Scientific Analysis/Calculation Administrative Change Notice

| 1. Document Number: | ANL-WIS-MD-000027 | 2. Revision: | 00 | 3. ACN: | 01 |
| 4. Title: | Features, Events, and Processes for the Total System Performance Assessment: Analyses | | | | |

Figure I-3a. Plan View of the UZ Flow Model Domain for Site Recommendation Showing Nearby Faults and Boreholes

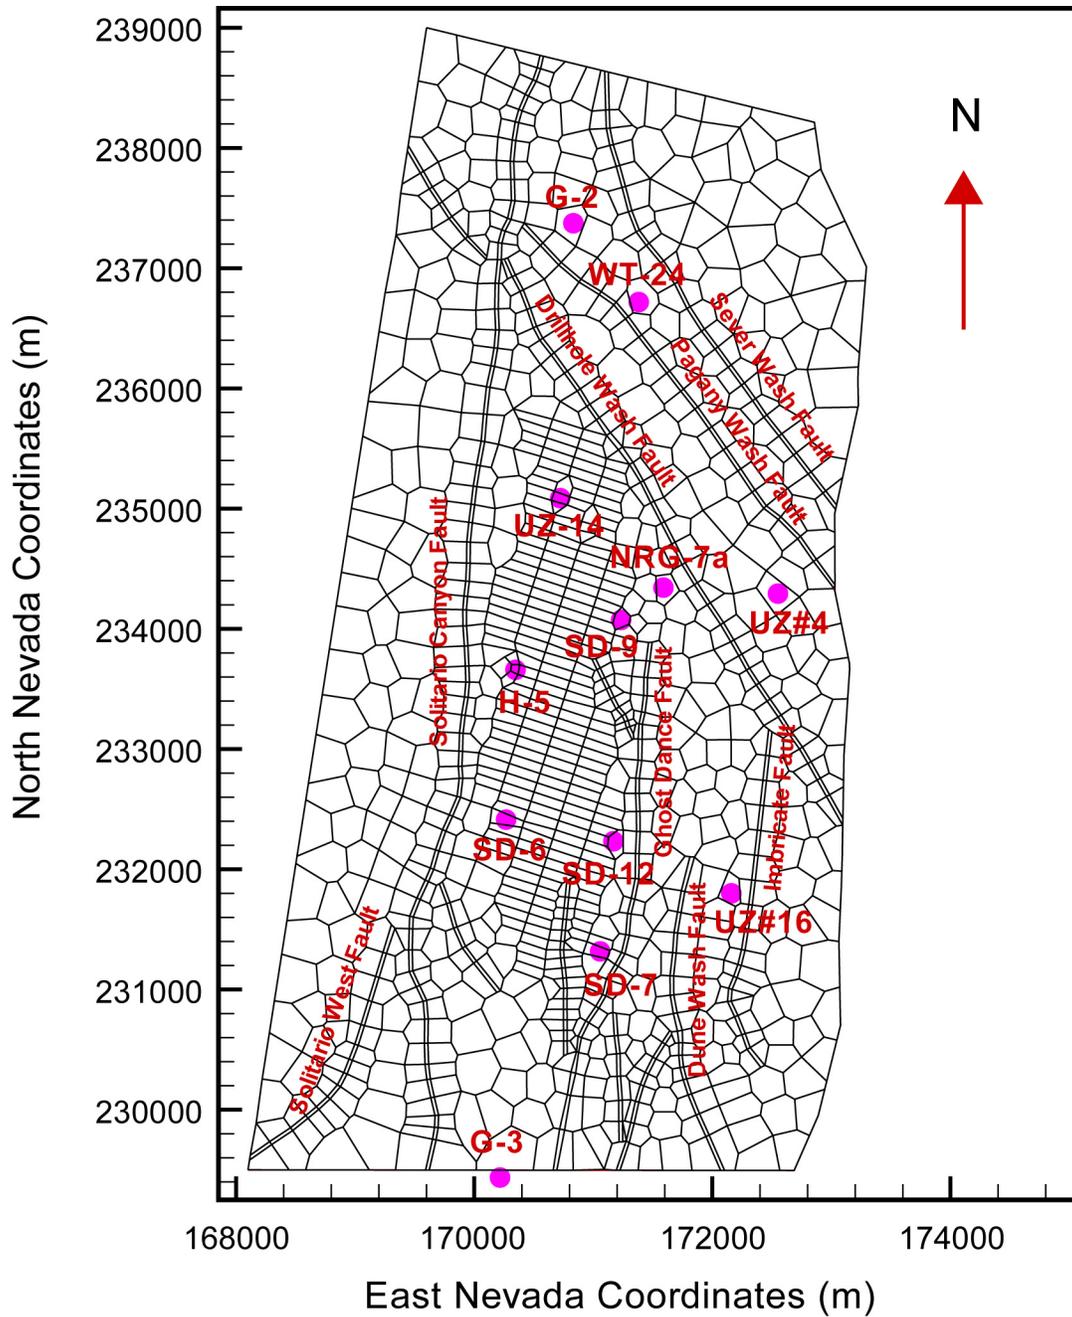
| I-11 | Figure I-3a is replaced by original source figure, which is more consistent with figure caption and its comparison Figure I-3b. | | | | |
